LARAMIE COUNTY PLANNING & DEVELOPMENT DEPARTMENT

MEMORANDUM

TITLE: PUBLIC HEARING regarding a Revised Commercial Site Plan for the Horse Creek Rock Quarry Expansion, located in a portion of land being situated in the E ½ Section 31, Section 32, T18N, R70W, and Section 5 and 6, T17N, R70W, Laramie County, WY.

REVISED COMMERCIAL SITE PLAN
HORSE CREEK ROCK QUARRY
EXPANSION

**HORSE CREEK ROCK
QUARRY SITE PLAN MAP**

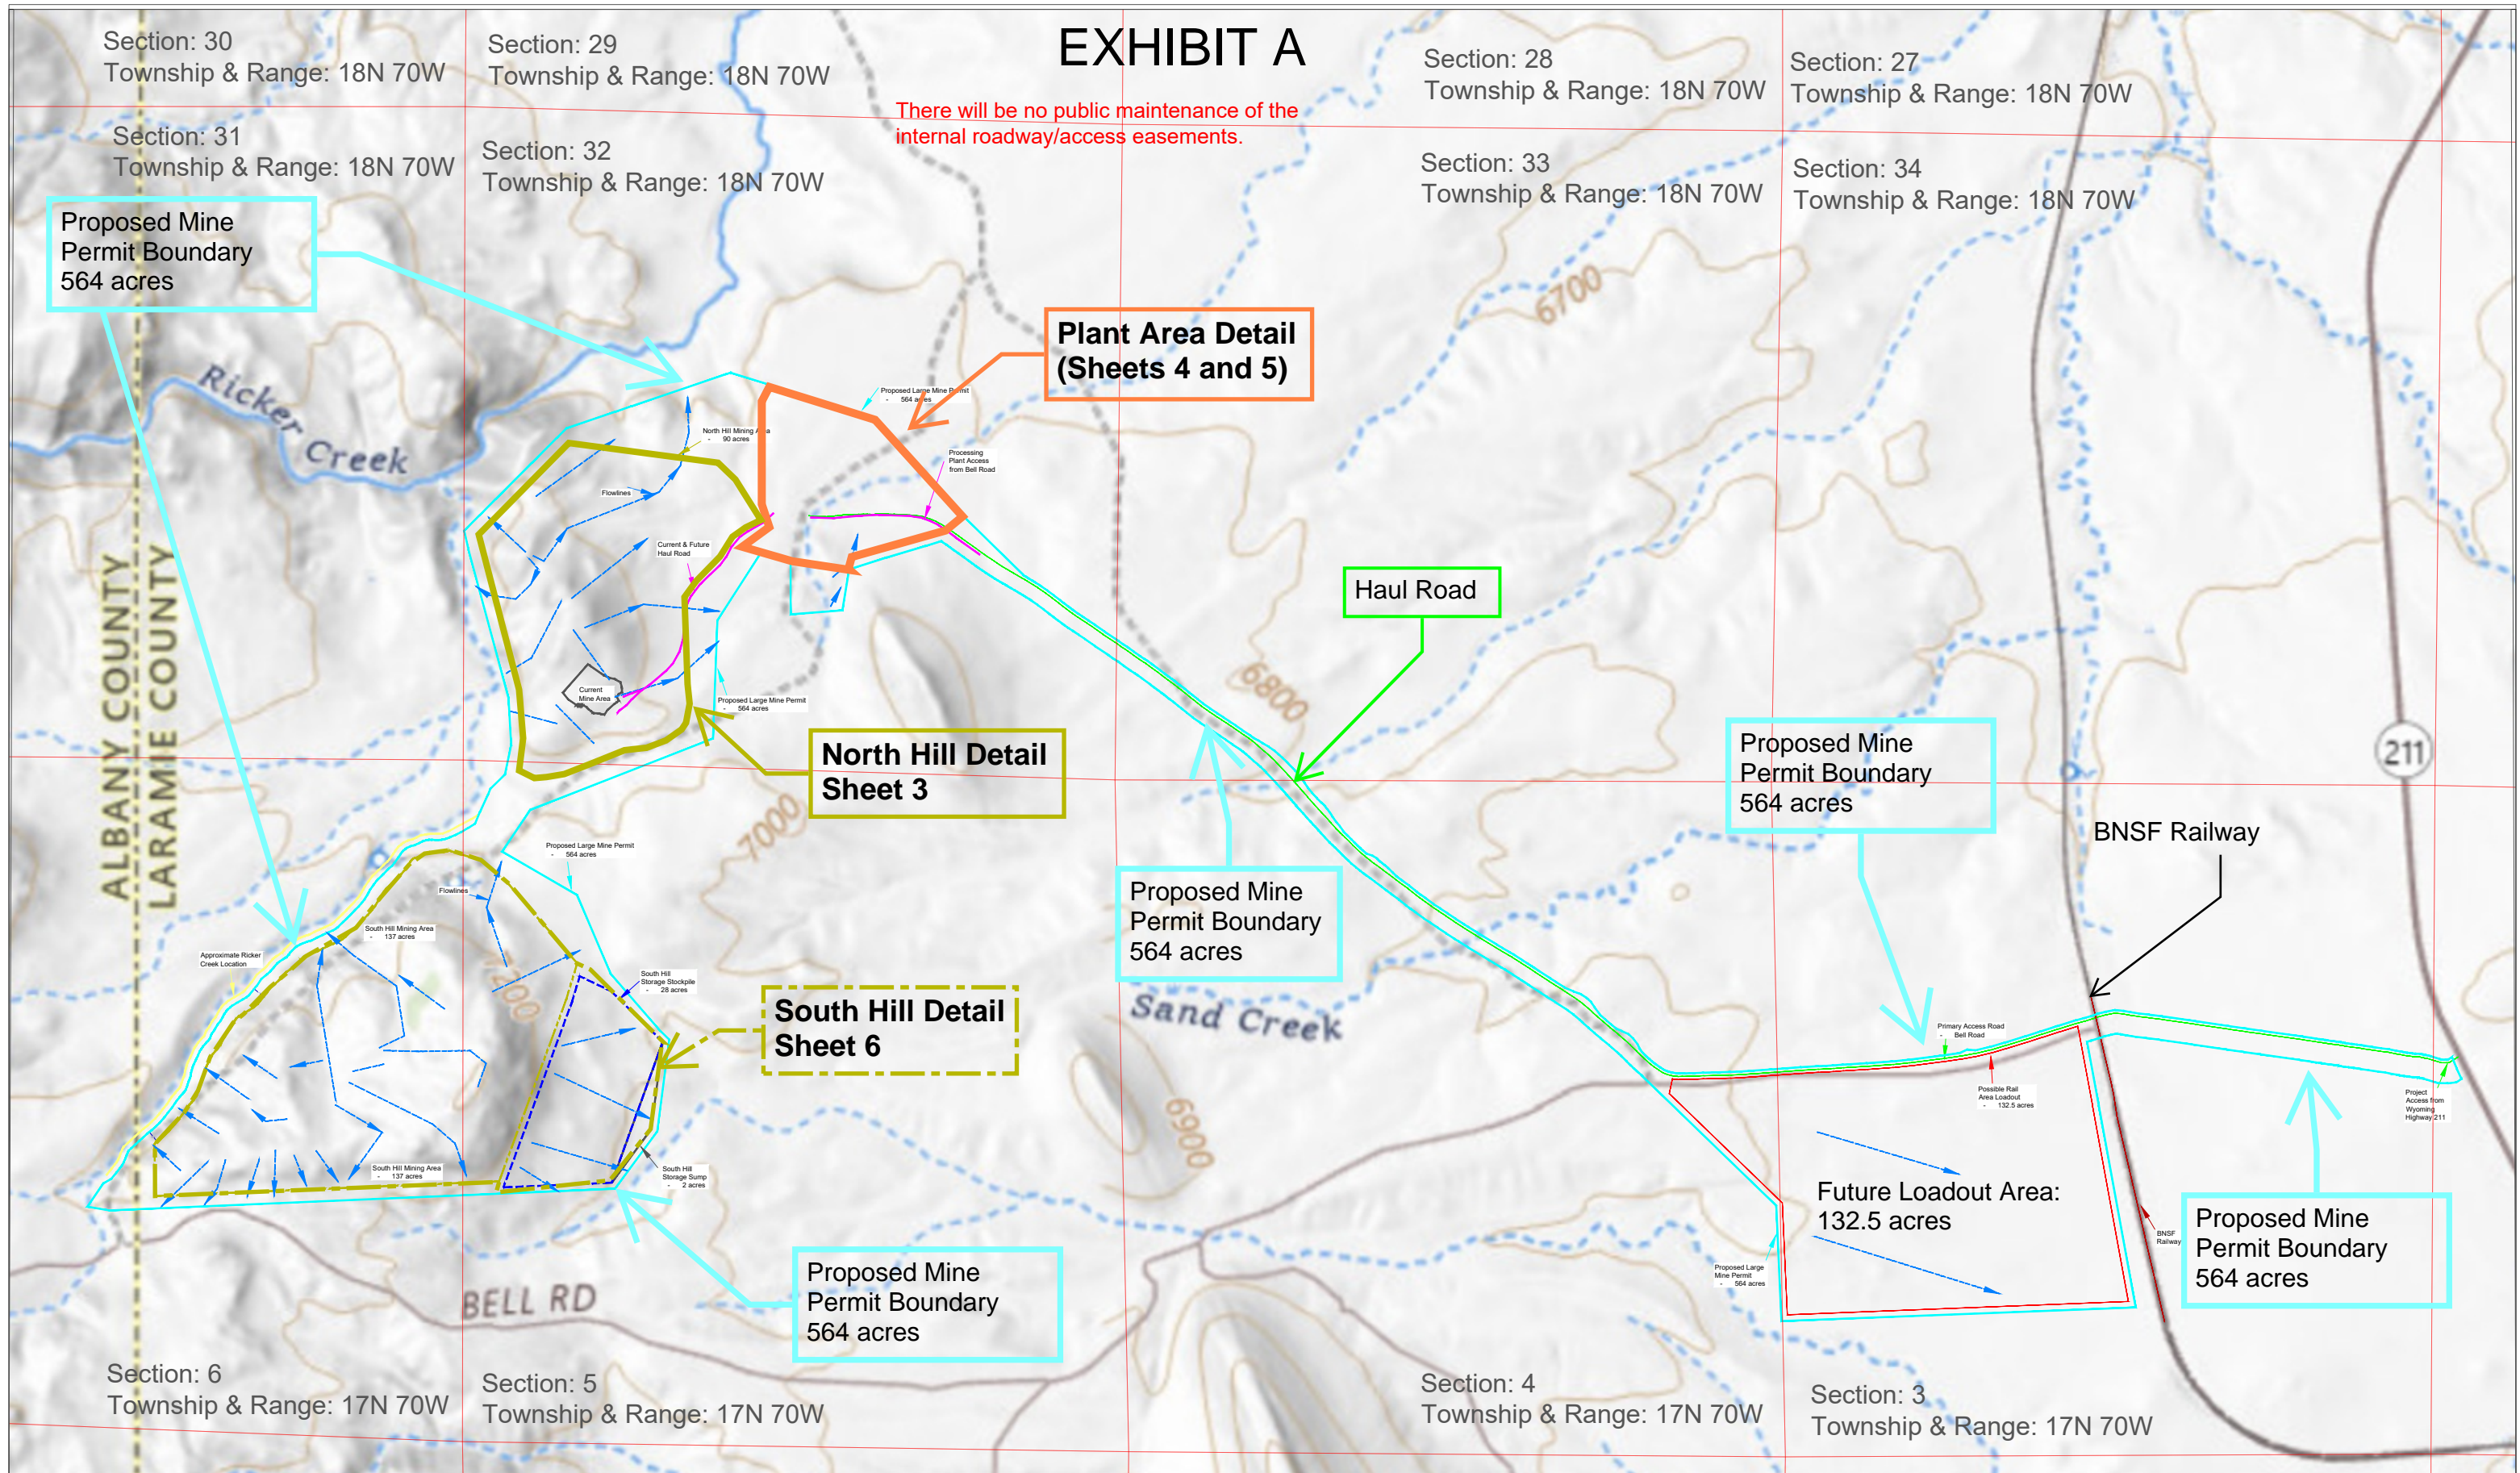
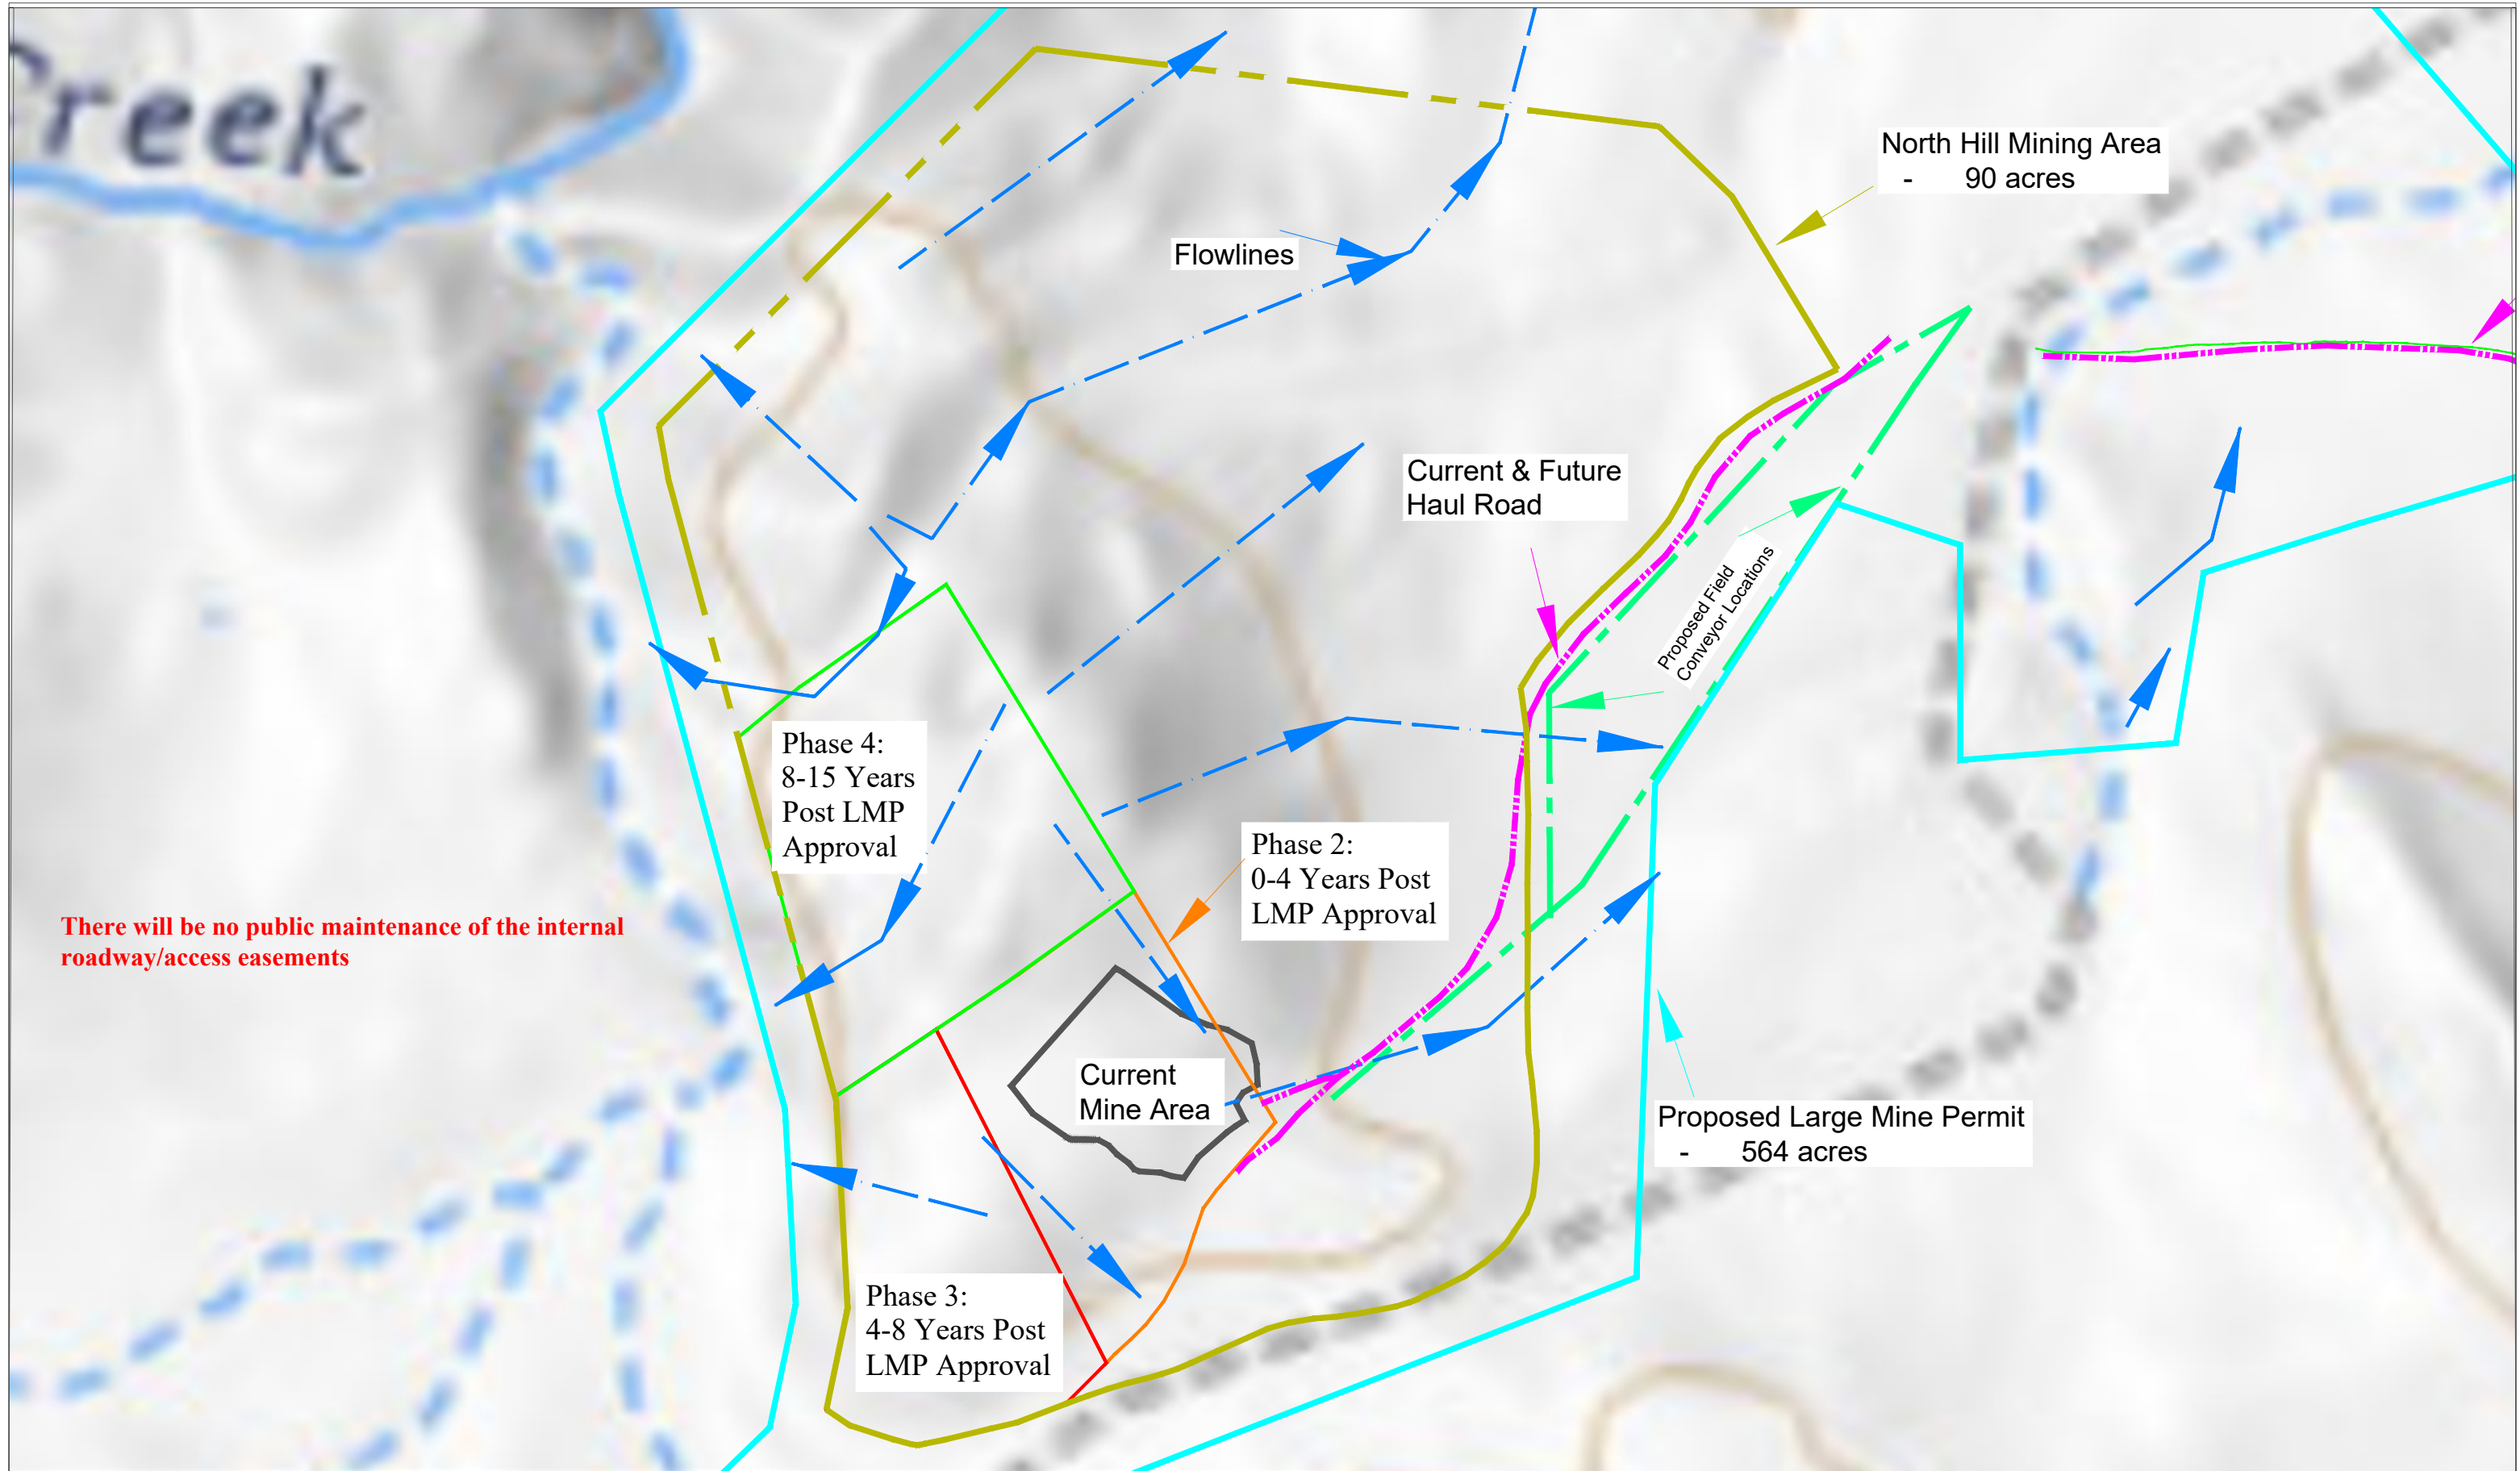
05/11/2026	05/11/2026	Workflow	BUILDING FIRE DEFICIENCY CODE REVIEW	NO DIMENSIONS PROVIDED FOR REVIEW. Premises identification shall be in accordance with 2024 IFC section 505 and 2024 IRC section 308, and 2024 IBC section 502.1. Fire Apparatus Roads required per 2024 IFC section 503. Fire protection water Supplies required per 2024 IFC section 507	DANIEL.PETERS@LARAMIECOUNTY.WY.GOV
<p>Attached to this document is a detailed site plan map for the project site's 3 structures, all of which are located in the Plant Site area of the project. Those 3 structures are: 1) Administration Trailer, 2) Weigh Scale, and 3) Storage Building/Quality Control Lab. Dimensions of each structure and the structures' distance from the site access road are provided on the map.</p>					
05/12/2026	05/12/2026	Application	PZ-26-00042 GENERAL	Ensure that all access and egress roads allow for emergency services	MATTHEW.BUTLER@LARAMIECOUNTY.WY.GOV

<p>LGE acknowledges this requirement: that a review of traffic and CMV weights will be reevaluated every 5 years or when a new sherriff administration is sworn in.</p>					
05/18/2026		Workflow	ENVIRONMENTAL HEALTH REVIEW GENERAL	Plan is to use porta potties and licensed pumper.	TIFFANY.GAERTNER@LARAMIECOUNTY.WY.GOV
05/18/2026		Workflow	ENVIRONMENTAL HEALTH REVIEW GENERAL	Plan is to use porta potties and licensed pumper.	TIFFANY.GAERTNER@LARAMIECOUNTY.WY.GOV
05/18/2026		Workflow	PUBLIC WORKS REVIEW GENERAL	1. At time of review by Public Works, the review engineer comments had not been submitted. If the comments need further conversation and/or clarification, please do not hesitate to reach out to Public Works. 2. All comments from the review engineer shall be addressed. 3. Any internal roadways on the site shall comply with the needs of emergency services. 4. Any work taking place within the boundaries of the designated floodplain and/or floodway will require an approved Floodplain Development Permit through the Laramie County Planning and Development office. 5. A note shall be added to the site plan indicating "there will be no public maintenance of internal roadways/access easements."	MOLLY.BENNETT@LARAMIECOUNTY.WY.GOV

<p>05/18/2026</p> <p>Workflow</p> <p>PUBLIC WORKS GENERAL REVIEW</p> <p>The existing access road at the Horse Creek site was constructed in adherence with the WYDOT access permit LA-07A-48569 (attached). All roads at the site are 20' wide to accommodate emergency services.</p> <p>No work is planned to occur in a flood plain at the Horse Creek Rock Quarry; as there are no flood plains present in the permit area. A flood plain map was provided in the Conditional Use Permit application for this operation, a copy of which is provided as an attachment to this document.</p> <p>The following phrase has been added to the Site Plan: "There will be no public maintenance of the internal roadway/access easements."</p>		<ol style="list-style-type: none"> 1. At time of review by Public Works, the review engineer comments had not been submitted. If the comments need further conversation and/or clarification, please do not hesitate to reach out to Public Works. 2. All comments from the review engineer shall be addressed. 3. Any internal roadways on the site shall comply with the needs of emergency services. 4. Any work taking place within the boundaries of the designated floodplain and/or floodway will require an approved Floodplain Development Permit through the Laramie County Planning and Development office. 5. A note shall be added to the site plan indicating "there will be no public maintenance of internal roadways/access easements." 	<p>MOLLY.BENNETT @LARAMIECOUNT YWY.GOV</p>

<p>The existing access road at the Horse Creek site was constructed in adherence with the WYDOT access permit LA-07A-48569 (attached). All roads at the site are 20' wide or greater to accommodate emergency service vehicles.</p> <p>No work is planned to occur in a flood plain at the Horse Creek Rock Quarry; as there are no flood plains present in the permit area. A flood plain map was provided in the Conditional Use Permit application for this operation, a copy of which is provided as an attachment to this document.</p> <p>The following phrase has been added to the Site Plan: "There will be no public maintenance of the internal roadway/access easements."</p>

The following phrase has been added to all of the maps associated with LGE's Site Plan application:

The updated Site Plan map packet (which includes the above phrase on all the maps) is provided at the end of this submittal; i.e. the last 6 pages of this PDF document.

There will be no public maintenance of the internal roadway/access easements.
